Ref.: AN 4/1.1.58-23/32

Subject: Proposal for the amendment of Annex 14,
Volume II concerning heliport specifications

PROPOSED AMENDMENT TO ANNEX 14, VOLUME II

**VOLUME II
(HELIPORTS)**

Figure 4-5.1. Curved approach and take-off climb surface for all FATOs

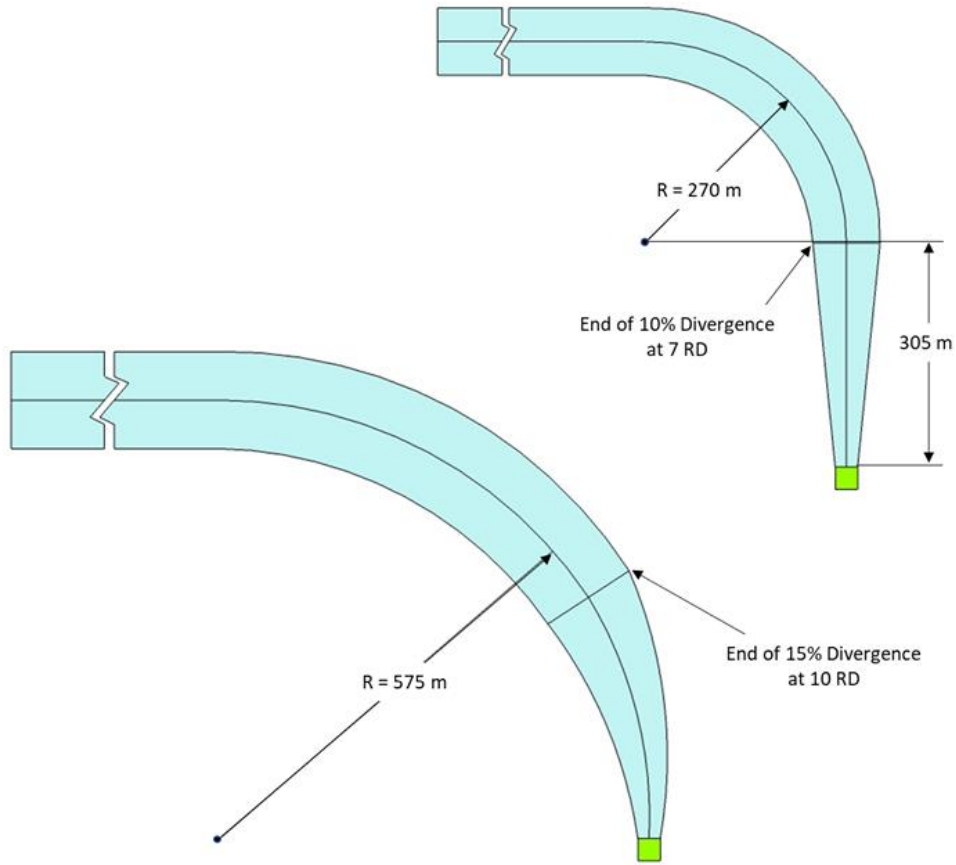
4.1.5 In the case of an approach surface involving a turn ~~or turns~~, the surface shall be a complex surface containing the horizontal normals to its centre line and the slope of the centre line shall be the same as that for a straight approach surface.

Note.— See Figure 4-51. For guidance on construction of turns in approach or take-off climb surfaces see the Heliport Manual (Doc 9261).

Editorial Note.—Delete Figures 4-1 to 4-4 and Figure 4-6 and associated notes in toto. Figure 4-5 to be renumbered as Figure 4-1.

Figure 4-27. Helideck obstacle-free sector

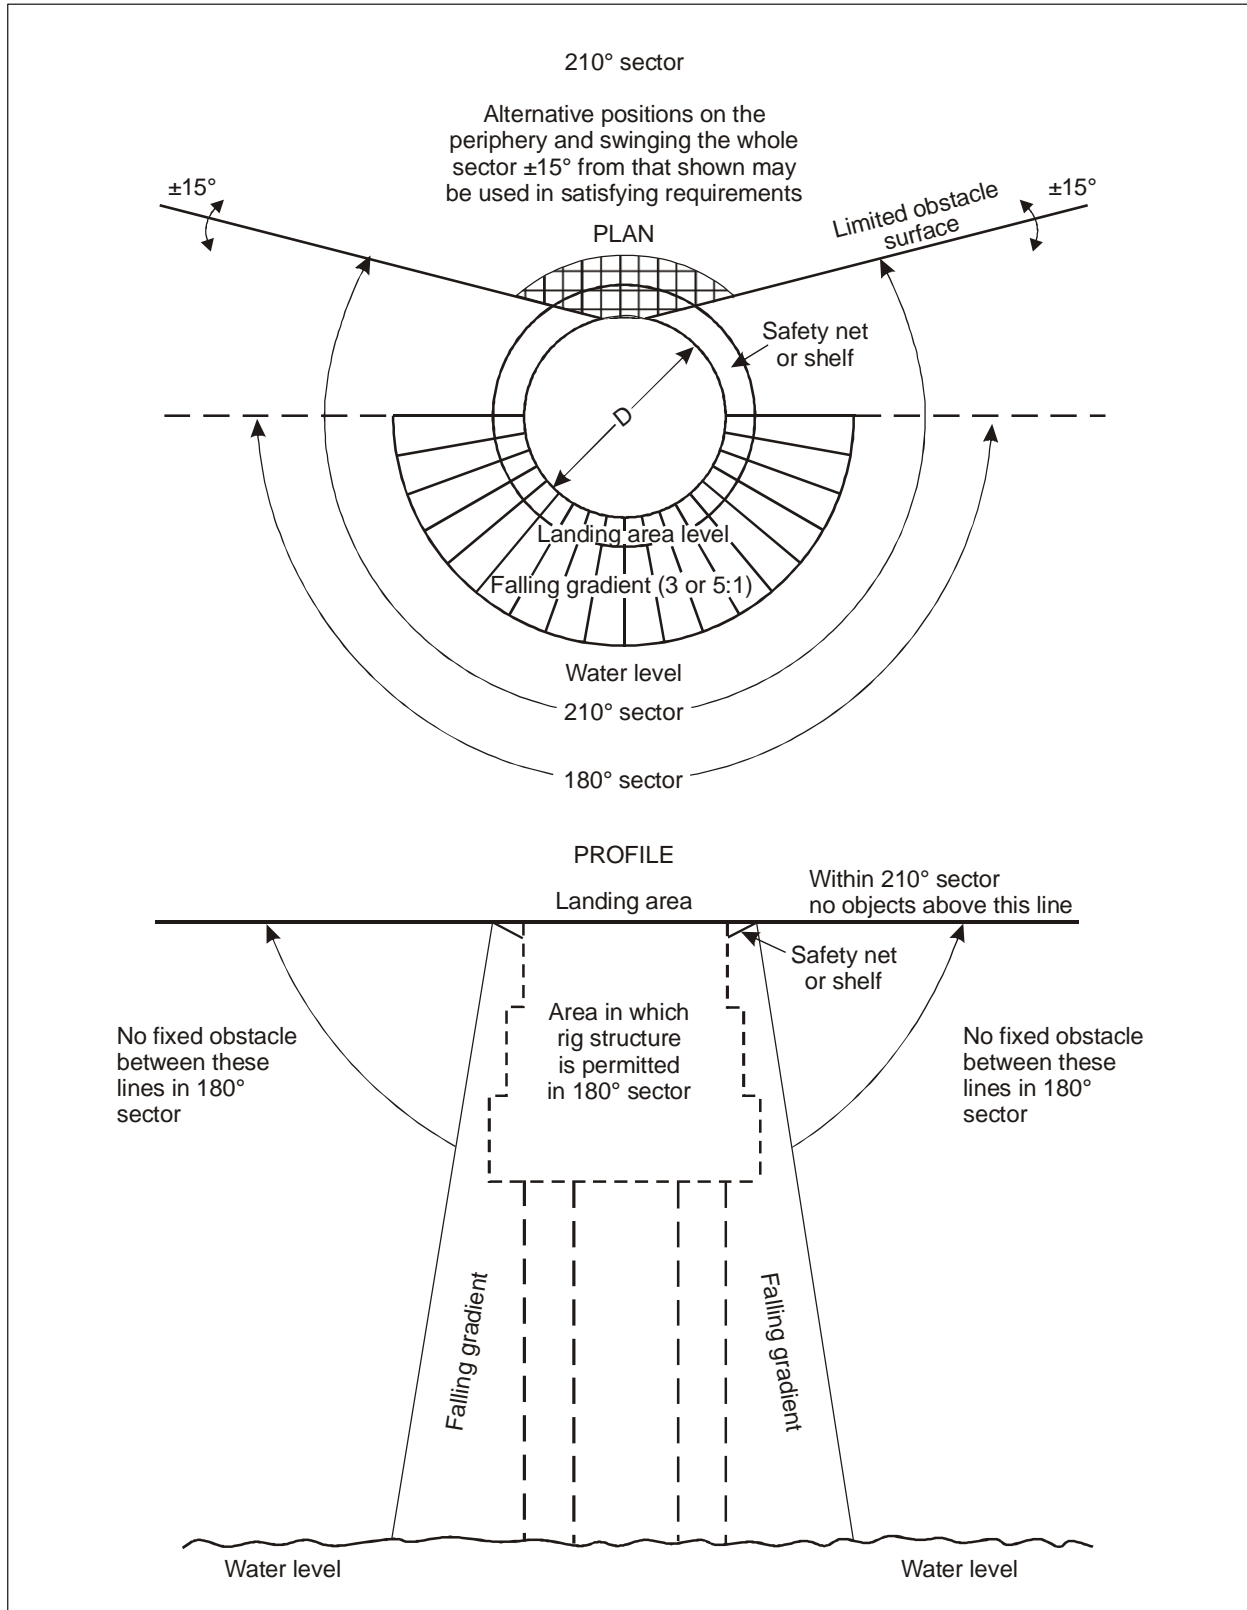
Note.— See Figure 4-27.

Figure 4-38. Helideck obstacle limitation sectors and surfaces for a FATO and coincidental TLOF of 1 D and larger

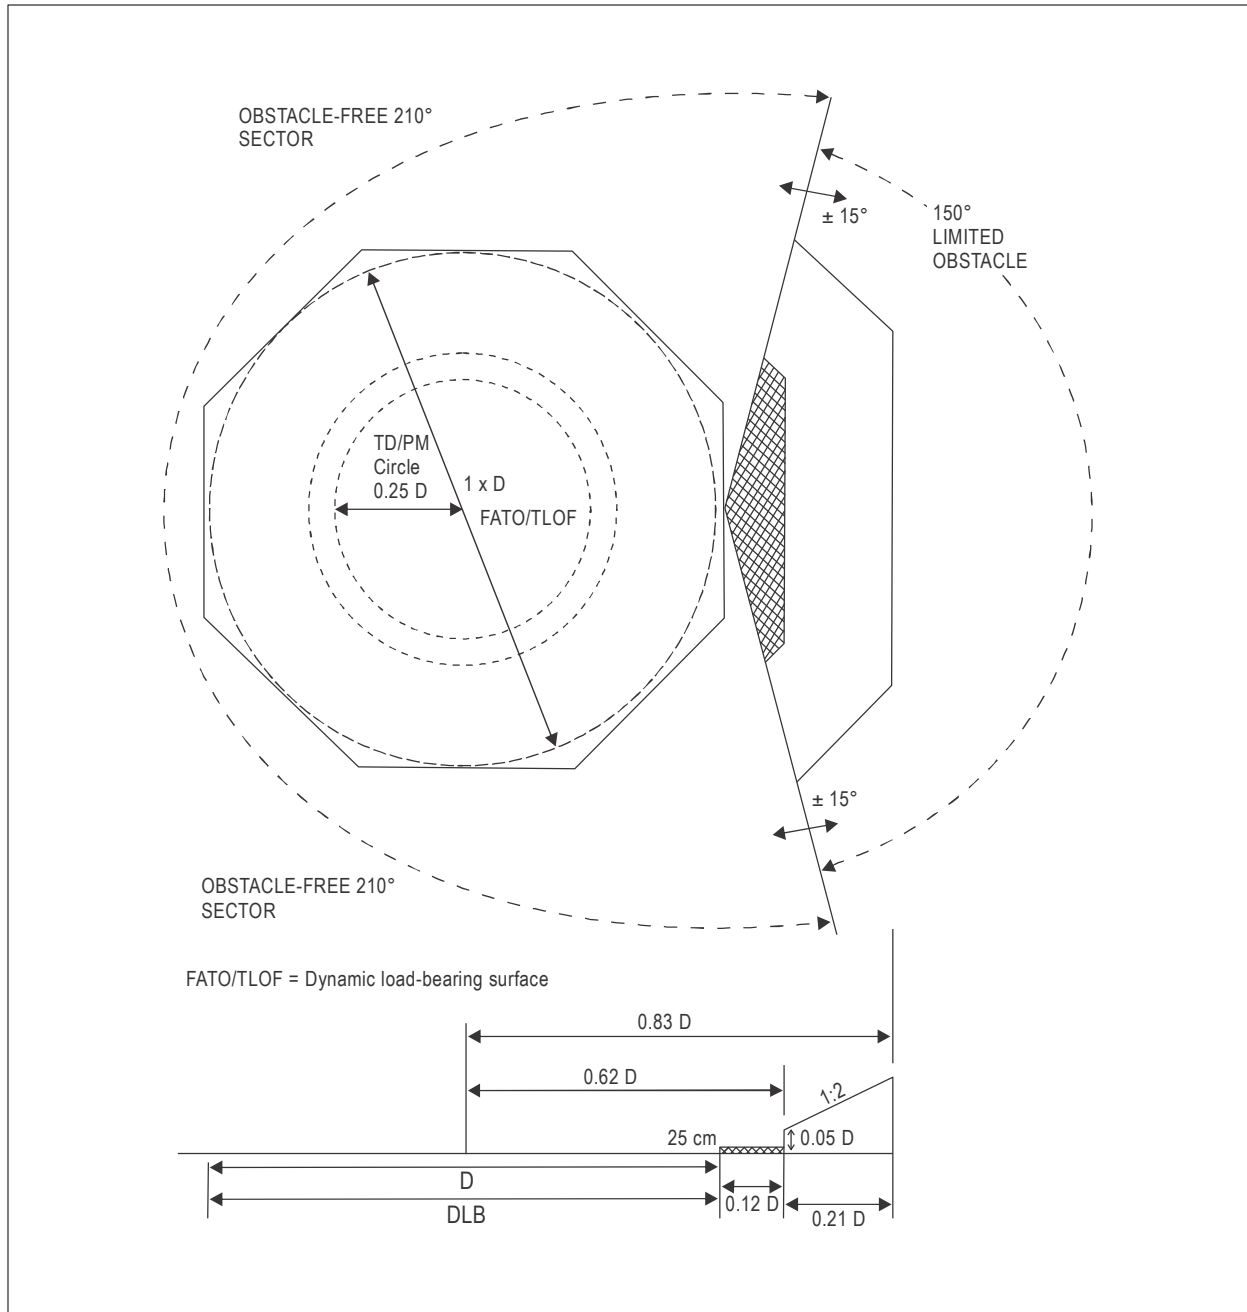
4.1.236 *Characteristics.* A limited obstacle sector shall not subtend an arc greater than 150 degrees. Its dimensions and location shall be as indicated in Figure 4-38 for a 1 D FATO with coincidental TLOF and Figure 4-49 for a 0.83 D TLOF.

4.2.105 For a TLOF of 1 D and larger, within the 150-degree limited obstacle surface/sector out to a distance of 0.12 D measured from the point of origin of the LOS, objects shall not exceed a height of 25 cm above the TLOF. Beyond that arc, out to an overall distance of a further 0.21 D measured from the end of the first sector, the limited obstacle surface rises at a rate of one unit vertically for each two units horizontally originating at a height 0.05 D above the level of the TLOF. (See Figure 4-38.)

Note.— Where the area enclosed by the TLOF perimeter marking is a shape other than circular, the extent of the LOS segments are represented as lines parallel to the perimeter of the TLOF rather than arcs. Figure 4-38 has been constructed on the assumption that an octagonal helideck arrangement is provided. Further guidance for square (quadrilateral) and circular FATO and TLOF arrangements is given in the Heliport Manual (Doc 9261).

Figure 4-49. Helideck obstacle limitation sectors and surfaces for a TLOF of 0.83 D and larger

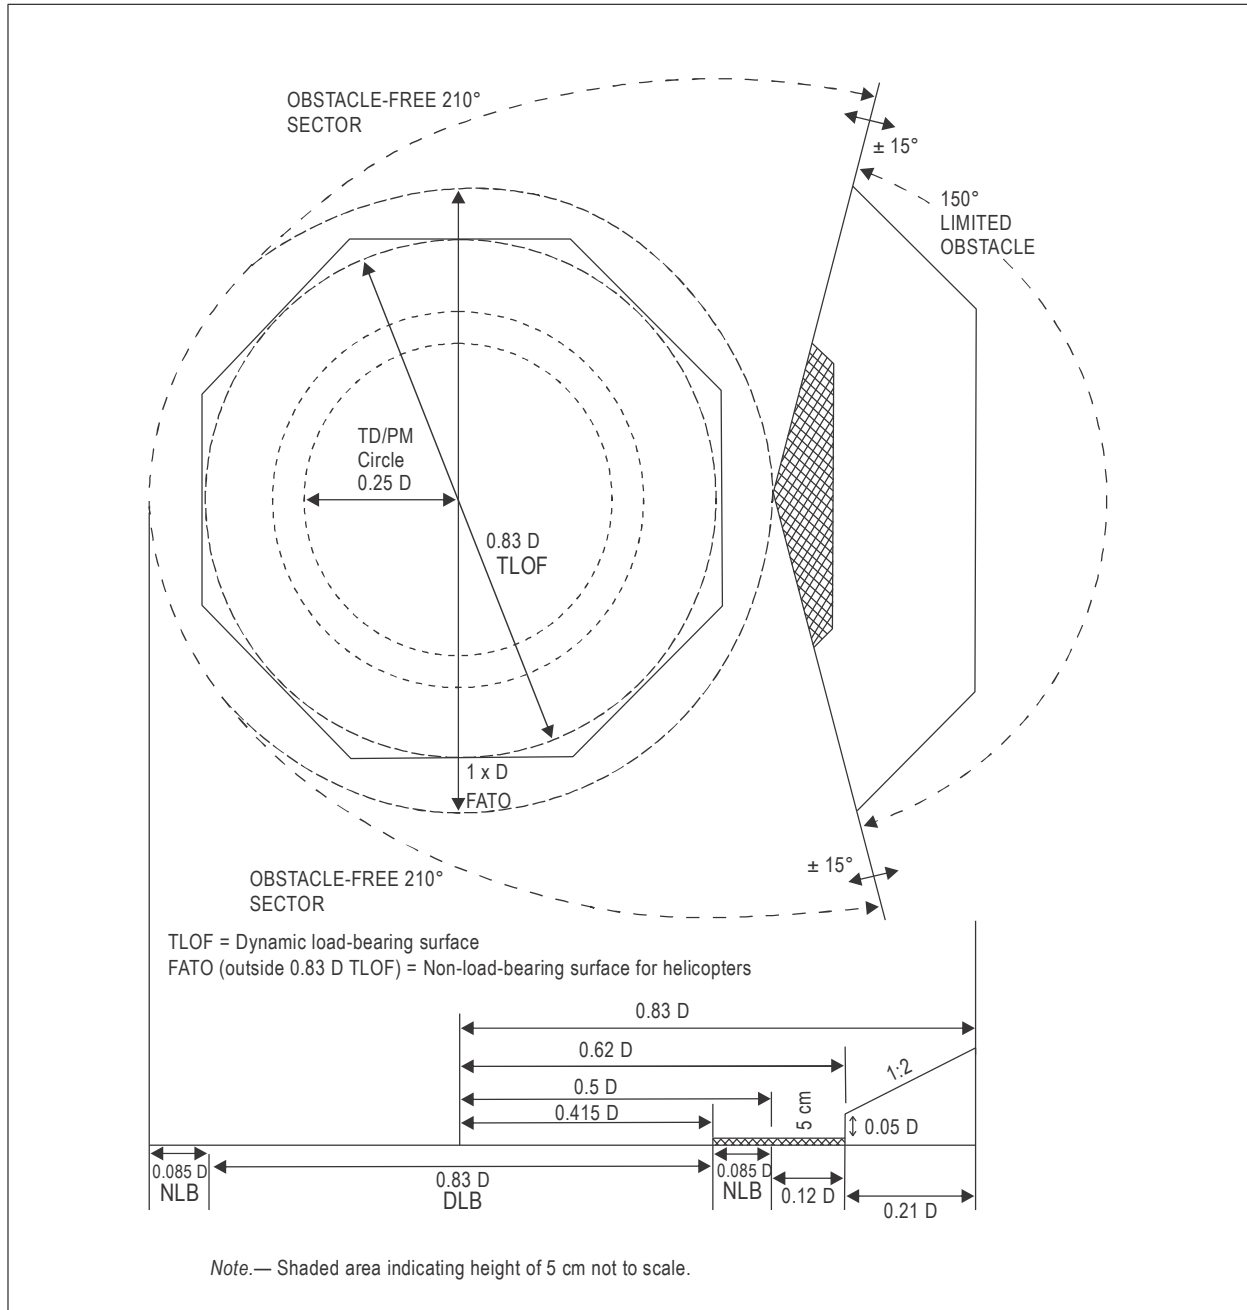
4.2.116 For a TLOF less than 1 D within the 150-degree limited obstacle surface/sector out to a distance of 0.62 D and commencing from a distance 0.5 D, both measured from the centre of the TLOF, objects shall not exceed a height of 5 cm above the TLOF. Beyond that arc, out to an overall distance of 0.83 D from the centre of the TLOF, the limited obstacle surface rises at a rate of one unit vertically for each two units horizontally originating at a height 0.05 D above the level of the TLOF. (See Figure 4-49.)

Note.— Where the area enclosed by the TLOF perimeter marking is a shape other than circular, the extent of the LOS segments are represented as lines parallel to the perimeter of the TLOF rather than arcs. Figure 4-49 has been constructed on the assumption that an octagonal helideck arrangement is provided. Further guidance for square (quadrilateral) and circular FATO and TLOF arrangements is given in the Heliport Manual (Doc 9261).

Figure 4-510. Amidship's location — shipboard heliport obstacle limitation surfaces

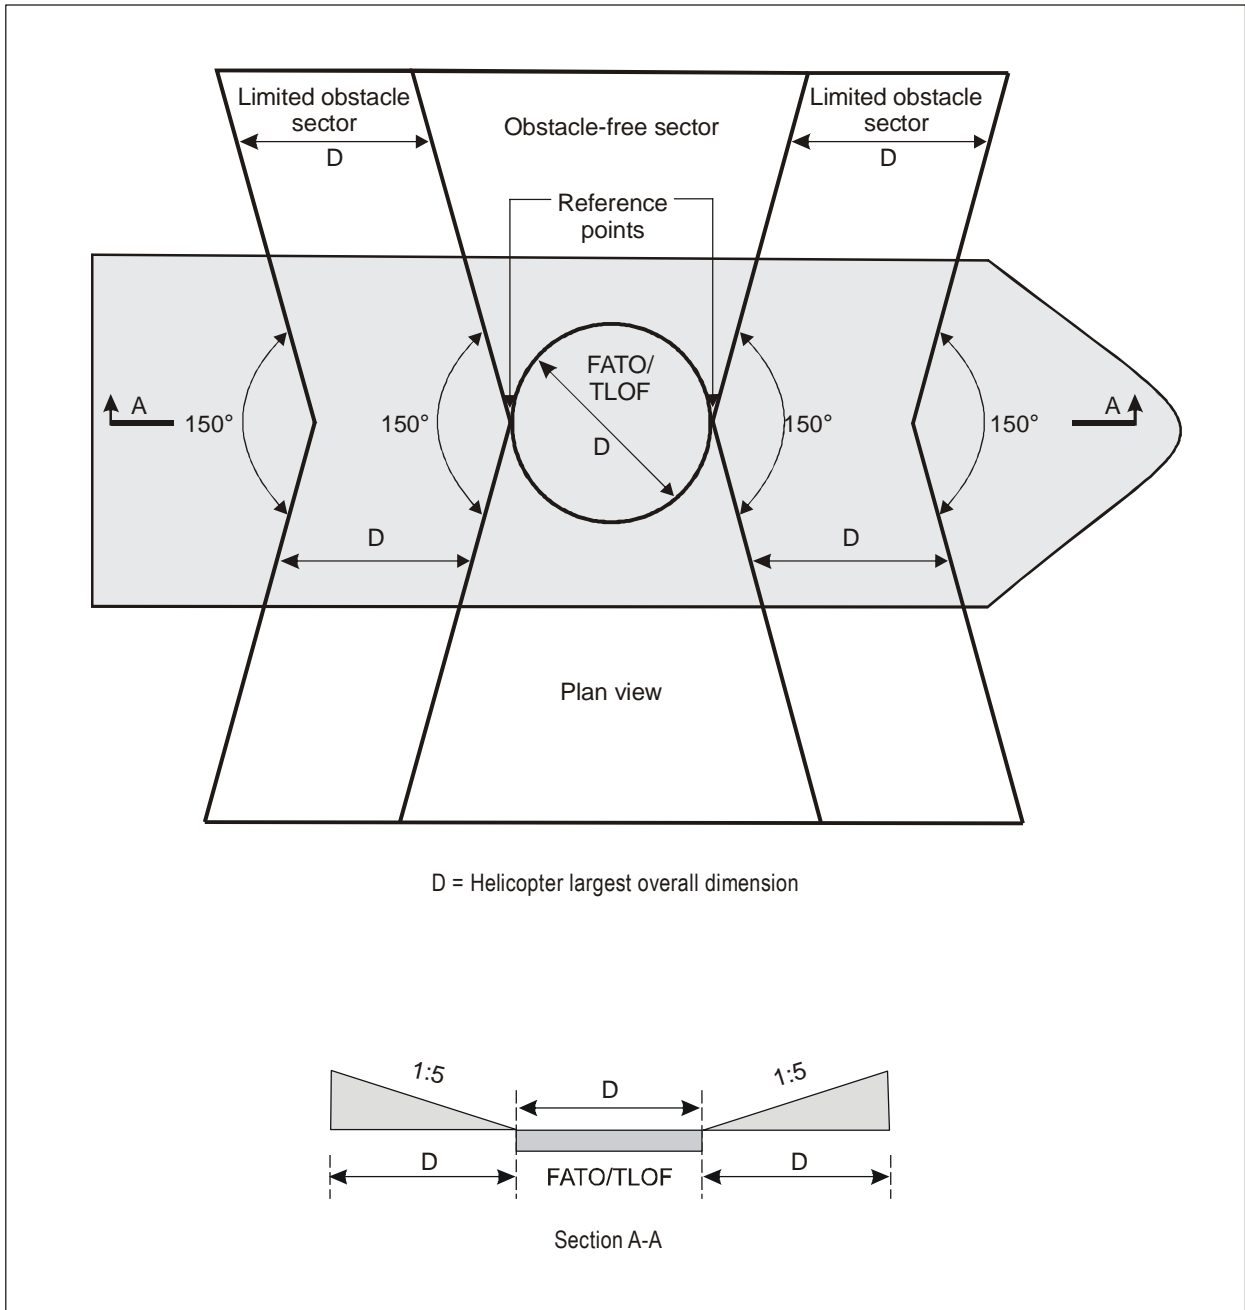
4.2.216 To provide further protection from obstacles fore and aft of the TLOF, rising surfaces with gradients of one unit vertically to five units horizontally shall extend from the entire length of the edges of the two 150-degree sectors. These surfaces shall extend for a horizontal distance equal to at least 1 D of the largest helicopter the TLOF is intended to serve and shall not be penetrated by any obstacle. (See Figure 4-540.)

Figure 4-712. Winching area of a ship

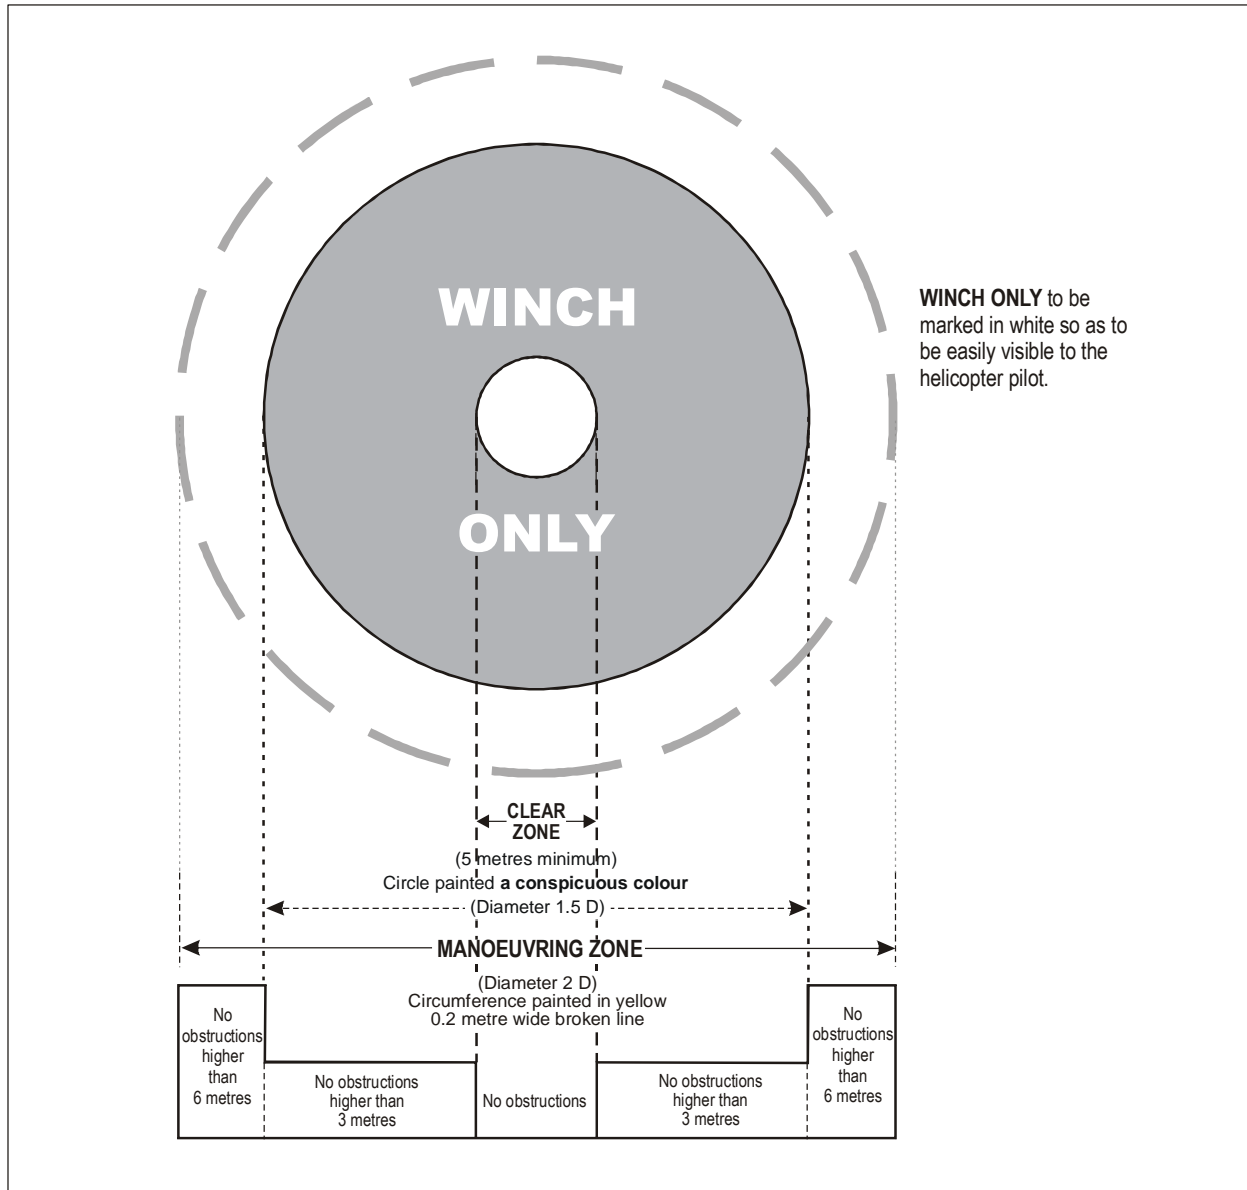
4.2.205 An area designated for winching on-board ships shall be comprised of a circular clear zone of diameter 5 m and, extending from the perimeter of the clear zone, a concentric manoeuvring zone of diameter 2 D. (See Figure 4-74.)

Figure 5-11. Helicopter beacon flash characteristics

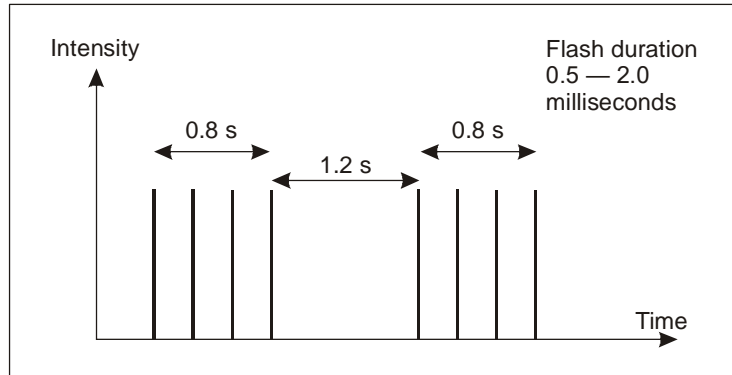
~~5.3.2.3 The heliport beacon shall emit repeated series of equispaced short duration white flashes in the format in Figure 5-11.~~

~~5.3.2.4 The light from the beacon shall show at all angles of azimuth.~~

<i>Origin:</i>	<i>Rationale:</i>
HDWG/14 ADOP/4	The detailed specification for helicopter beacons is transferred to the <i>Helicopter Manual</i> (Doc 9261) to allow operators some flexibility on the systems that they may (optionally) provide.

Figure 5-13. Approach lighting system

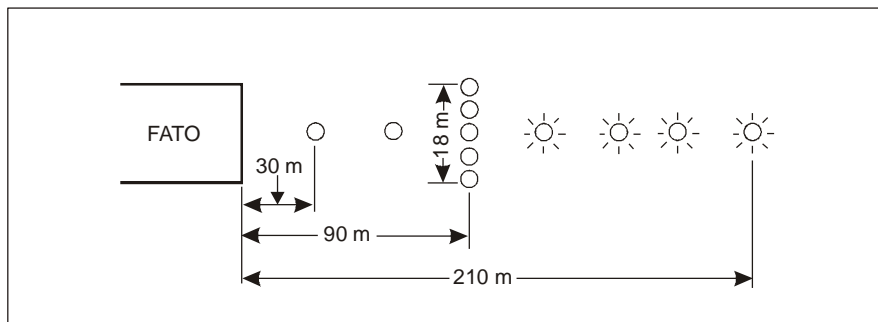
~~5.3.3.3 Recommendation.—An approach lighting system should consist of a row of three lights spaced uniformly at 30 m intervals and of a crossbar 18 m in length at a distance of 90 m from the perimeter of the FATO as shown in Figure 5-13. The lights forming the crossbar should be as nearly as practicable in a horizontal straight line at right angles to, and bisected by, the line of the centre line lights and spaced at 4.5 m intervals. Where there is the need to make the final approach course more conspicuous, additional lights spaced uniformly at 30 m intervals should be added beyond the crossbar. The lights beyond the crossbar may be steady or sequenced flashing, depending upon the environment.~~

~~5.3.3.4 The steady lights shall be omnidirectional white lights.~~

~~5.3.3.5 Sequenced flashing lights shall be omnidirectional white lights.~~

Origin:	Rationale:
HDWG/14 ADOP/4	The detailed specification for approach lighting systems is transferred to the <i>Heliport Manual</i> (Doc 9261) to allow operators some flexibility on the systems that they may (optionally) provide.
